# U.S. EPR Design Certification

## RAI 579 Response – US EPR FSAR Markups

April 28, 2014

# Meeting Purpose and Outline

Figure 5.4-19 Level Control During Midloop Operation

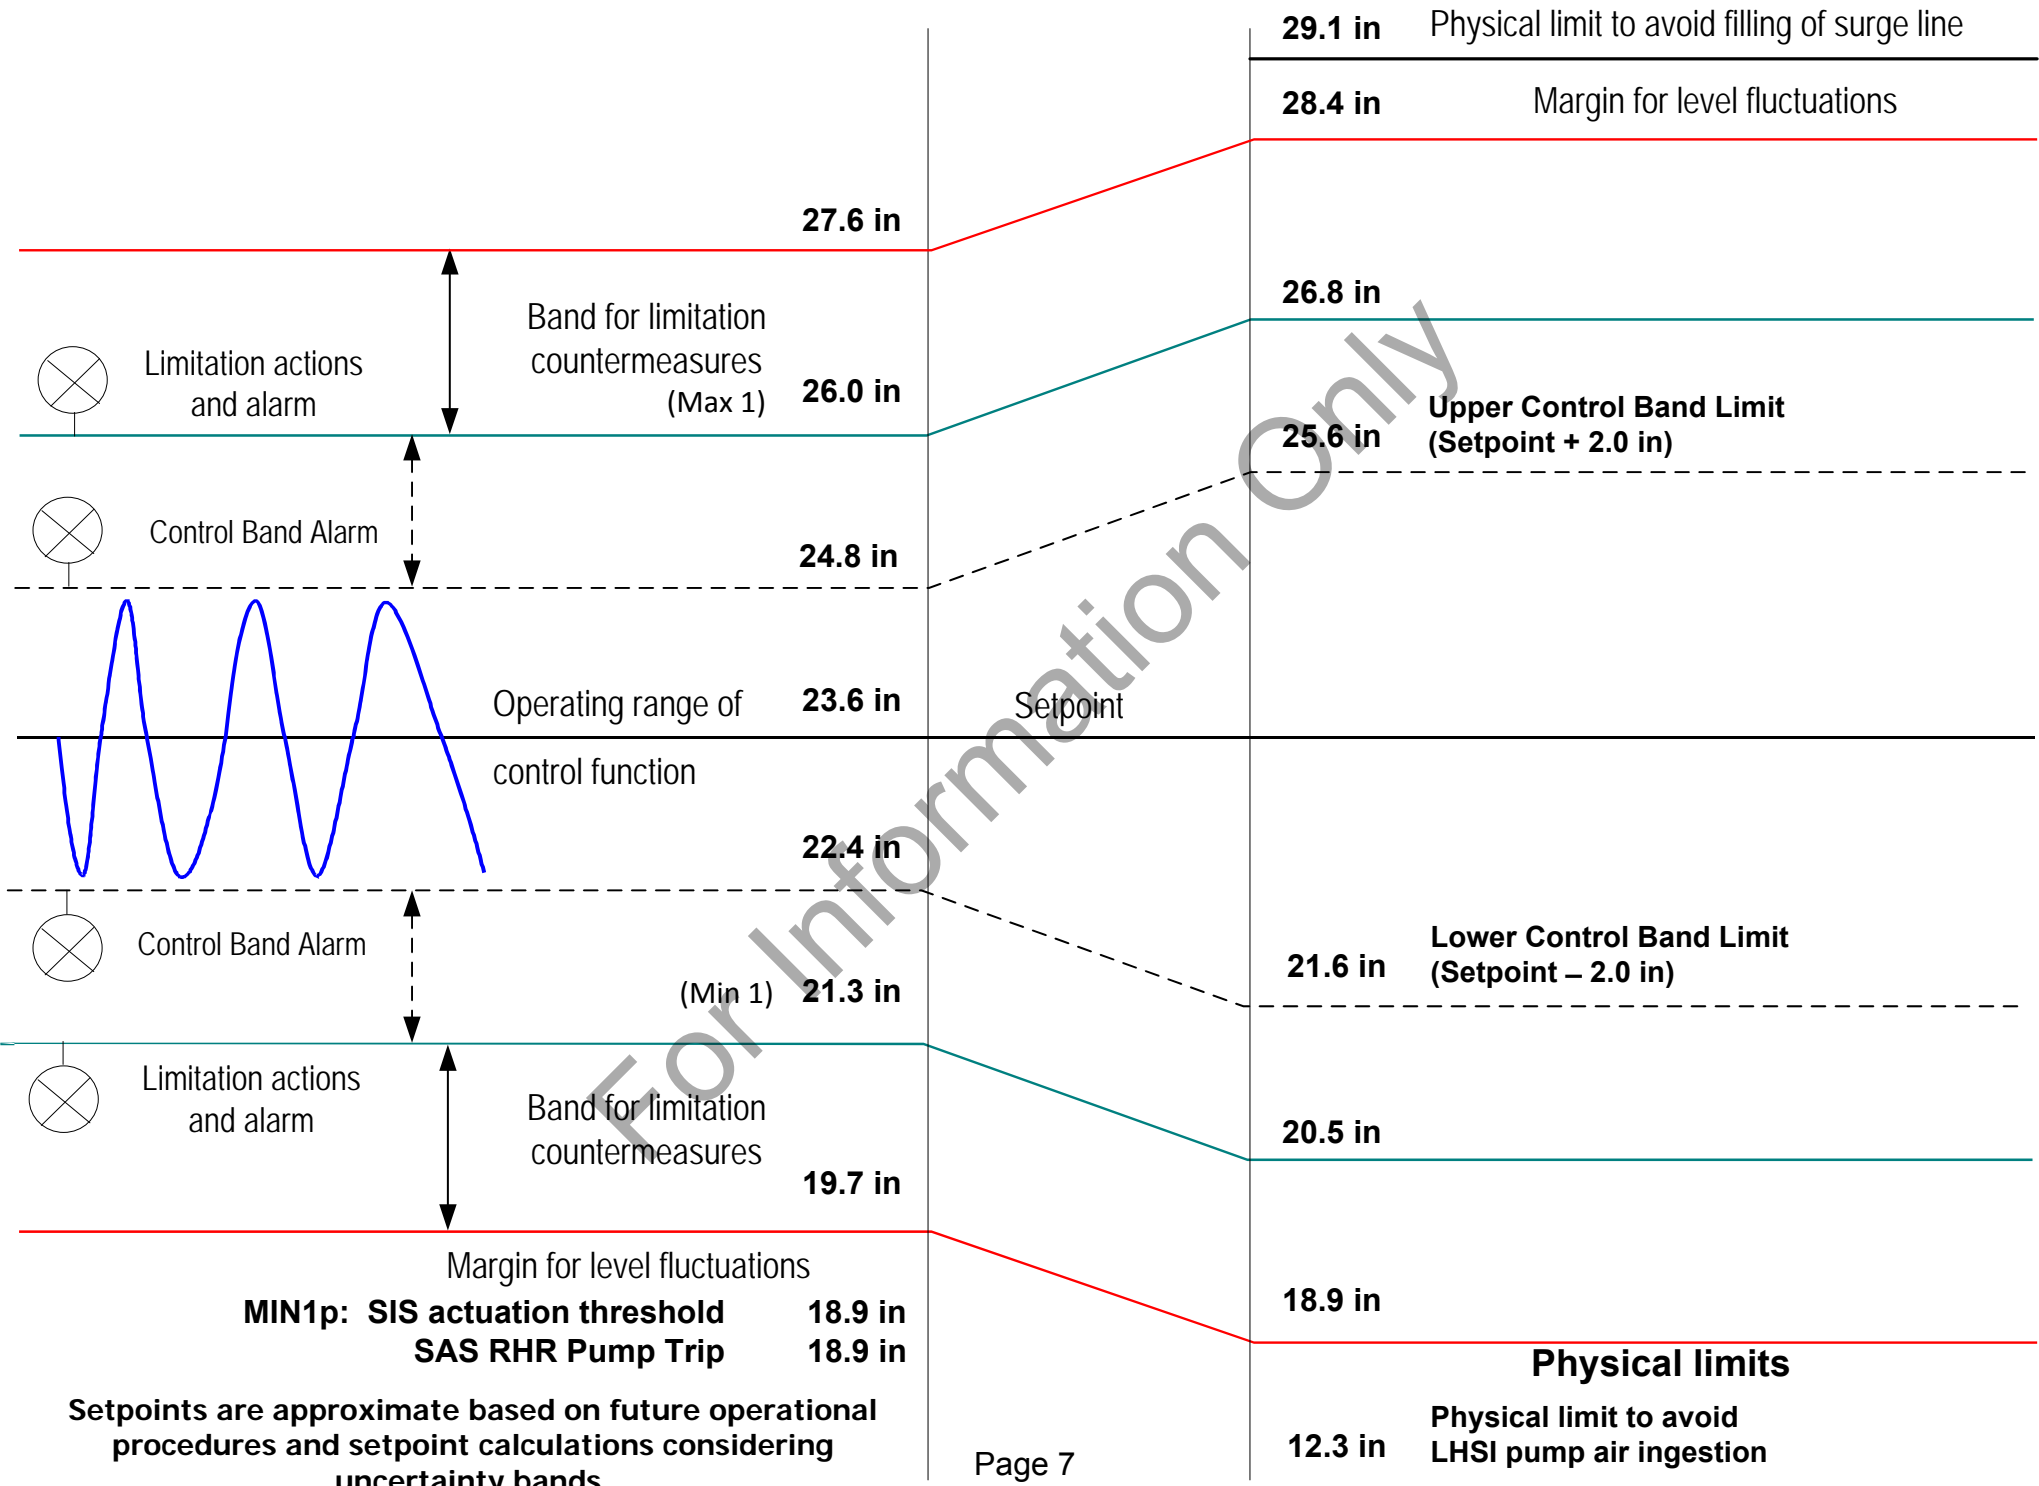
<p>Loop Level Control Function</p>	<p>The RCS loop level control during mid-loop operation is regulated by the CVCS high pressure charging pumps and CVCS low pressure reducing station. <u>See Section 7.7.2.2.3 for a description of loop level control.</u> After the loop level control mode has been manually validated, certain automatic protection functions are actuated. <u>The nominal control band is shown on Figure 5.4-19.</u></p>
--	--

Max1 RCS Loop Level Limitation Function	This setpoint initiates an open command for the CVCS low pressure letdown control valve in order to prevent inadvertent filling of the steam generator bowls <del>(without nozzle dams)</del> . <u>The Max1 setpoint is shown on Figure 5.4-19.</u>
Min1 RCS Loop Level Limitation Function	This setpoint initiates full closure of the CVCS low pressure letdown control valve and the RHR and CVCS isolation valves in order to protect the LHSI pumps that are operating in RHR mode. This function covers the entire temperature range of the RHR system operation. <u>The Min1 setpoint is shown on Figure 5.4-19.</u>
Min1p RCS Loop Level Safety Function	This setpoint initiates the SIS in case of low RCS level in the primary loops in the event of a sudden drop in RCS level during mid-loop operation <del>in order to protect the RHR pumps and maintain adequate core cooling.</del> <u>to provide RCS makeup and a stage 1 containment isolation signal.</u>  <u>This setpoint also initiates automatic stop of the LHSI pumps in RHR mode to prevent cavitation of operating LHSI pumps due to air ingestion. The Min1p setpoint is shown on Figure 5.4-19.</u>

Figure 7.6-9 - SIS / RHR Automatic Trip of LHSI Pump (in RHR Mode) on Low  $\Delta P_{sat}$  Interlock

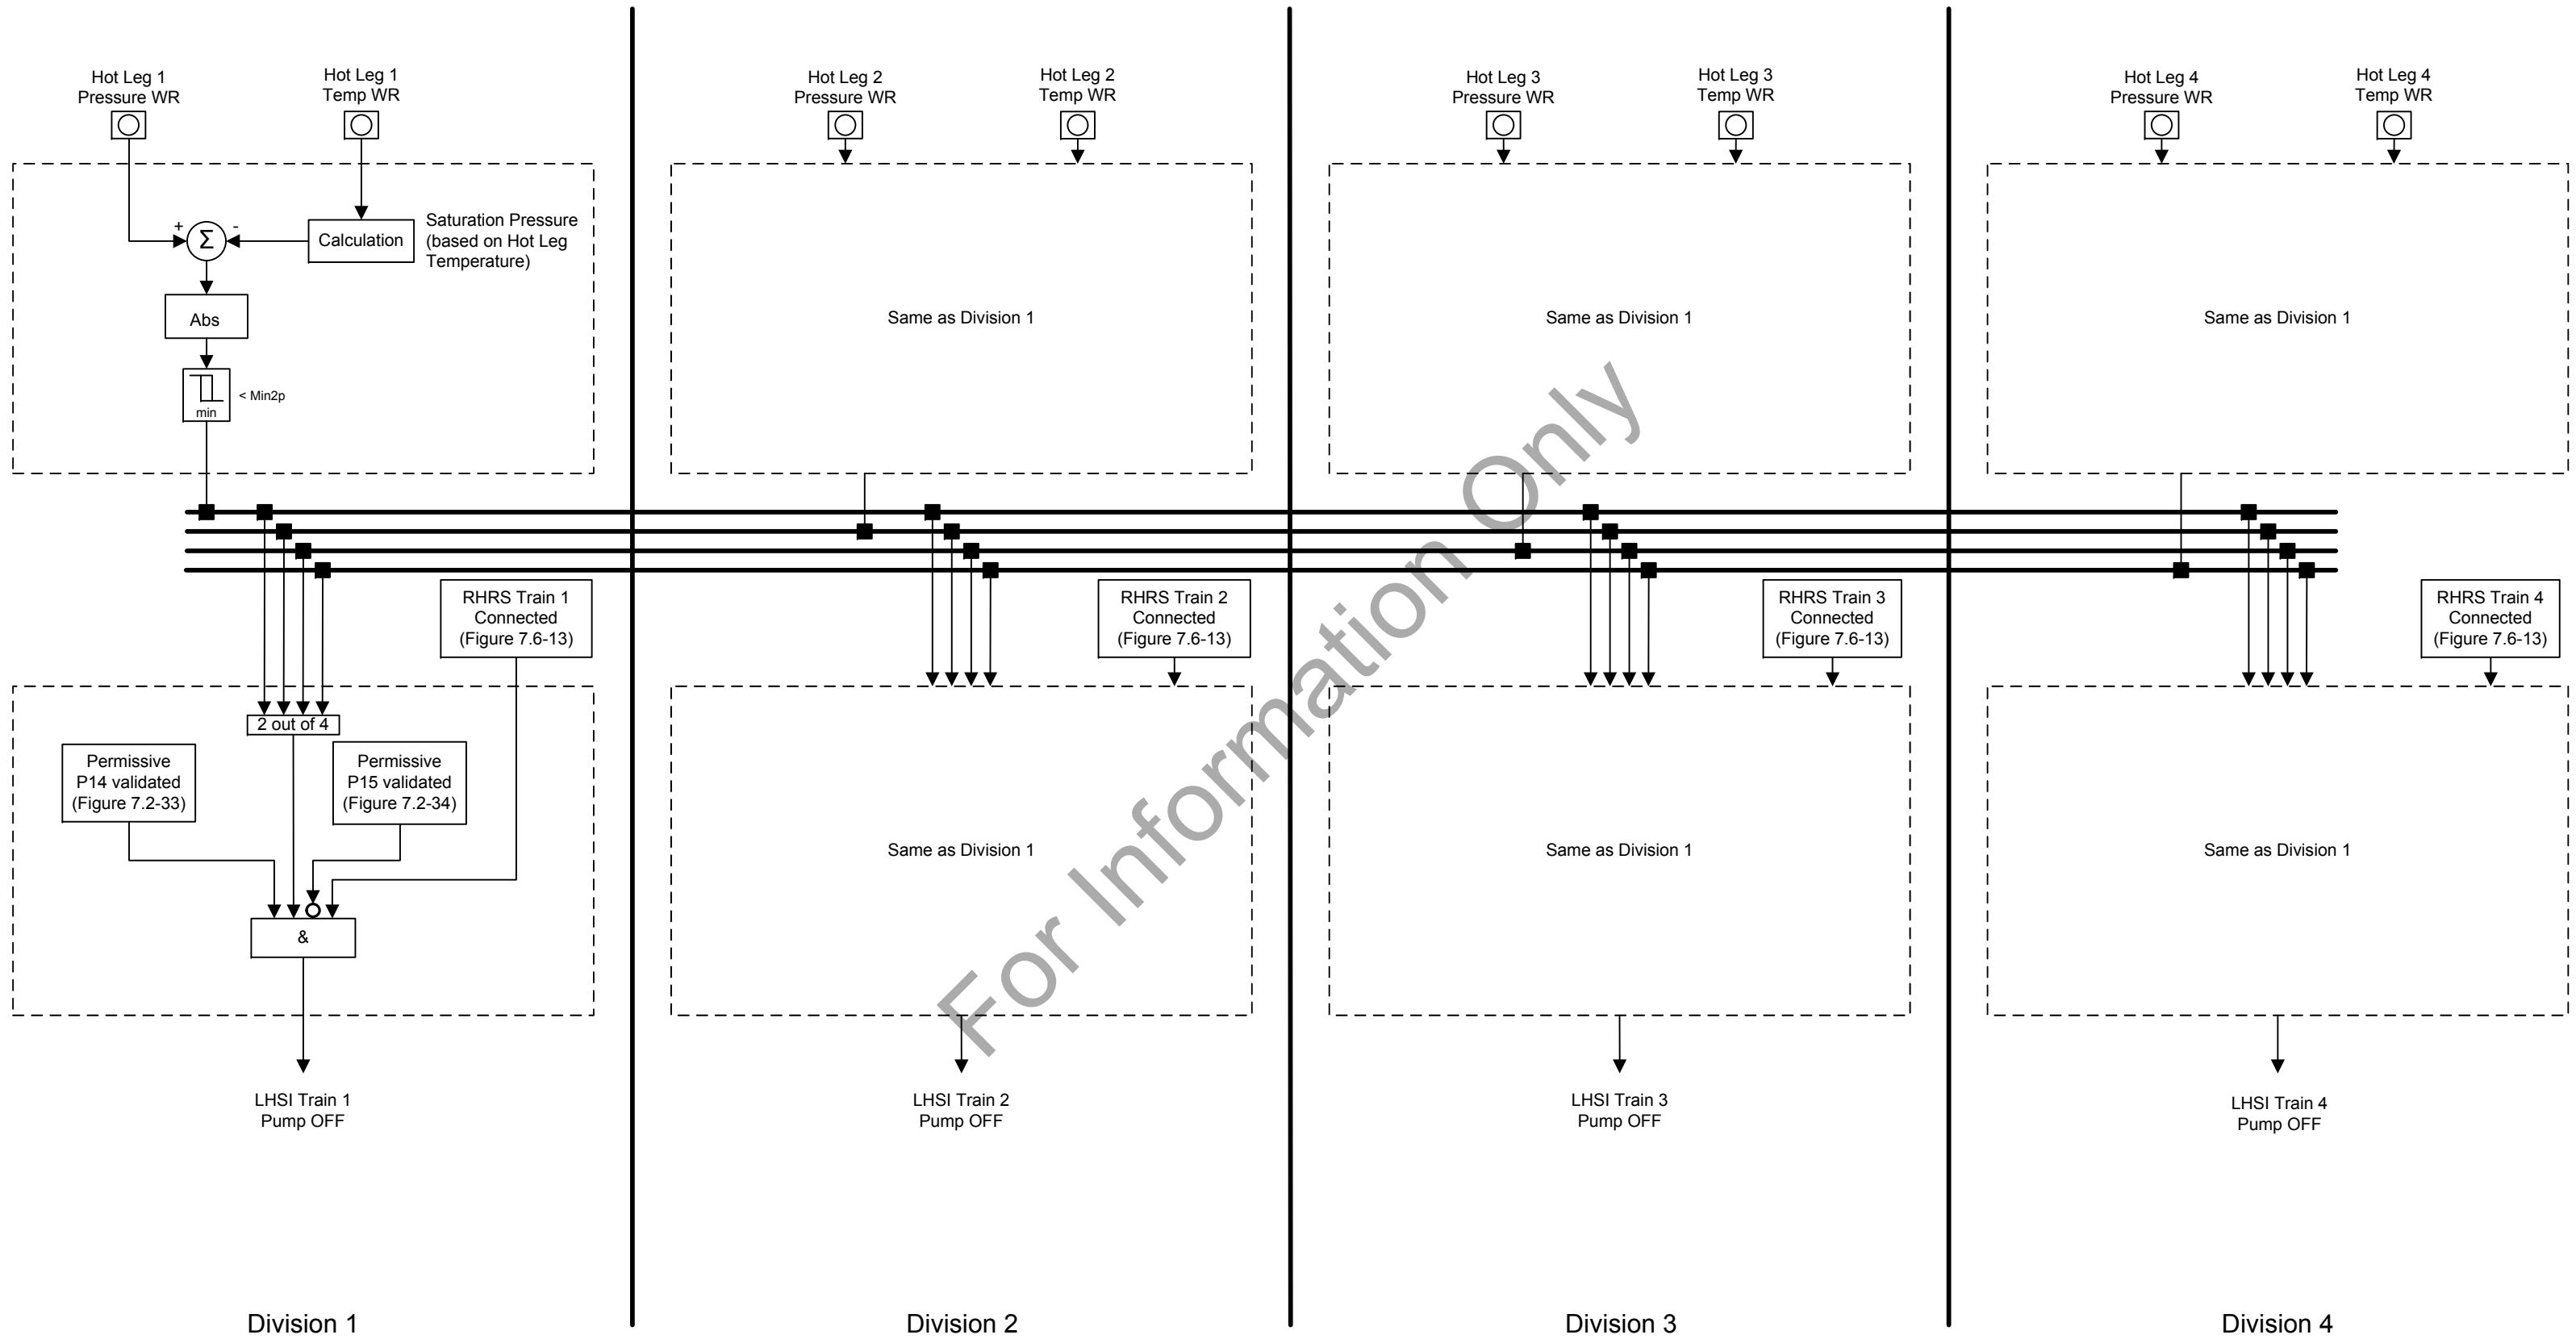
#### **7.6.1.2.2 SIS / RHRS Automatic Trip of LHSI Pump (in RHR Mode) on Low $\Delta P_{sat}$ Interlock**

The SIS/RHRS has a safety-related function to provide the RCS residual heat removal to reach cold shutdown, refueling modes and to control primary temperature. The function to automatically trip the LHSI pump upon a low  $\Delta P_{sat}$  signal supports the safety-related function of providing residual heat removal by maintaining LHSI pump operability by shutting down the pump to prevent pump damage due to inadequate net positive suction head (NPSH) or unavailability due to steam binding following a failure that results in RCS conditions approaching saturation. The functional logic is shown in Figure 7.6-9 - SIS/RHRS Automatic Trip of LHSI Pump (in RHR Mode) on Low  $\Delta P_{sat}$  Interlock.

Figure 7.6-10 - SIS / RHR Automatic Trip of LHSI Pump (in RHR Mode) on Low RCS Loop Level Interlock

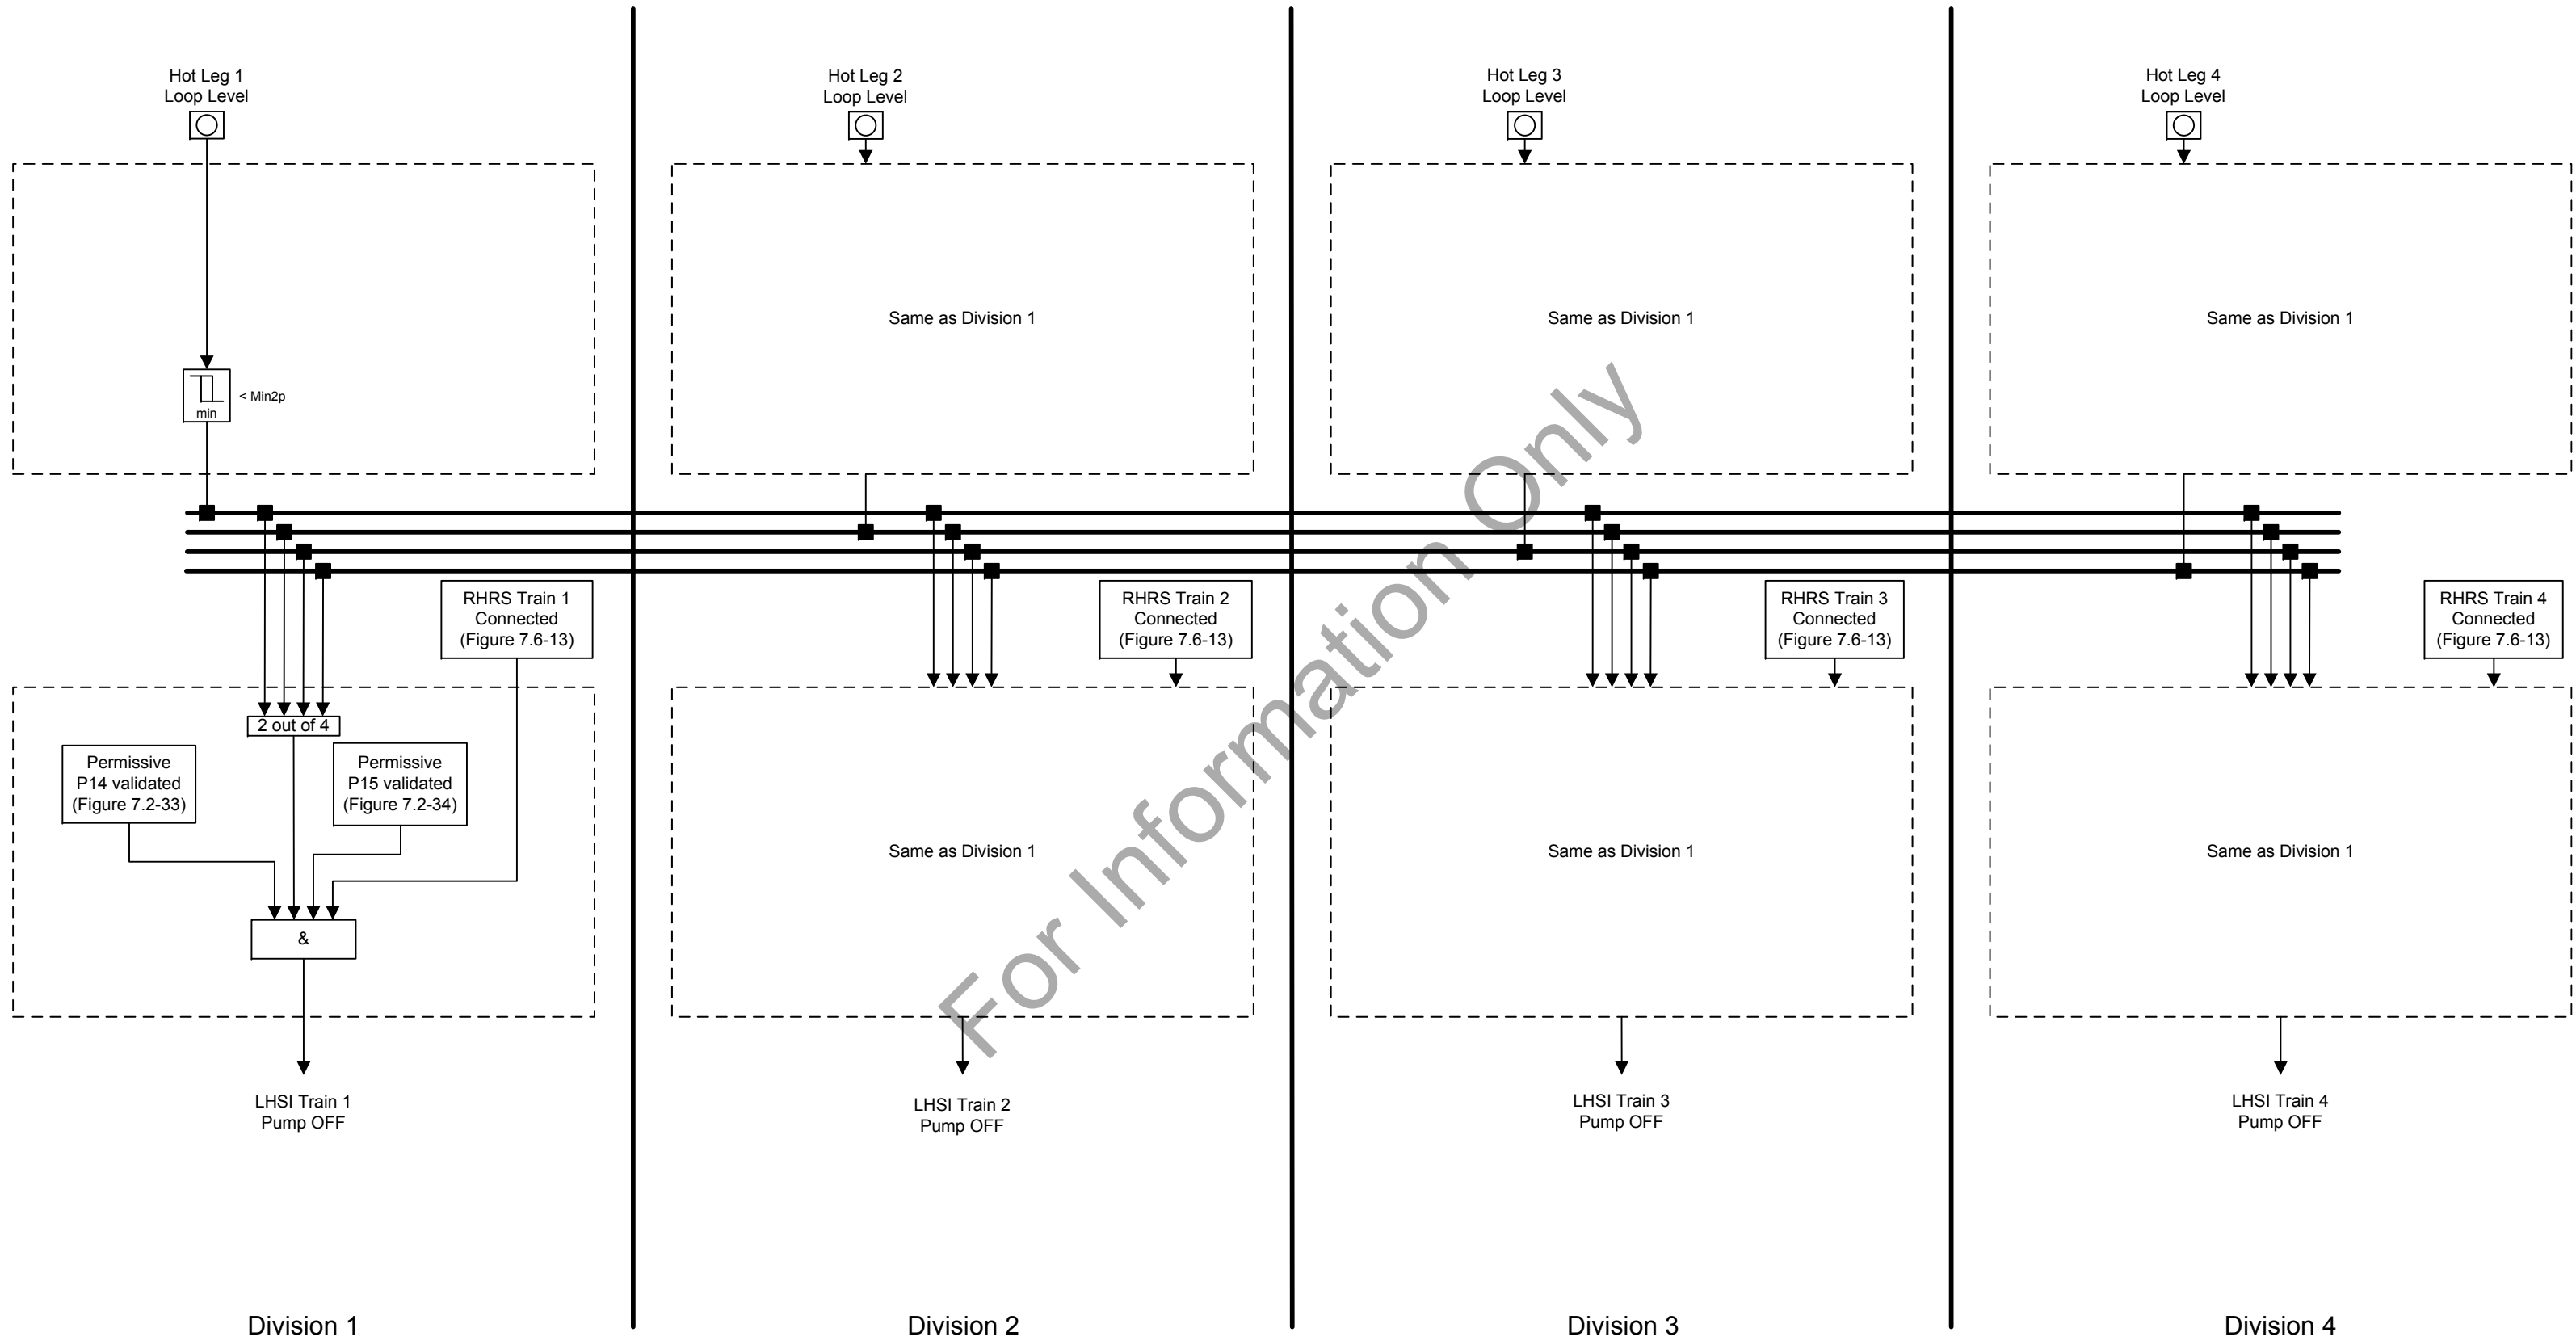
### **7.6.1.2.3 SIS / RHRS Automatic Trip of LHSI Pump (in RHR Mode) on Low RCS Loop Level Interlock**

The SIS/RHRS has a safety-related function to provide the RCS residual heat removal to reach cold shutdown, refueling modes and to control primary temperature. The function to automatically trip the LHSI pump upon a low RCS loop level signal supports the safety-related function of providing residual heat removal by maintaining LHSI pump operability by shutting down the pump to prevent pump damage or unavailability due to air binding following a failure that results in low RCS loop level. The functional logic is shown in Figure 7.6-10 - SIS/RHRS Automatic Trip of LHSI Pump (in RHR Mode) on Low RCS Loop Level Interlock.
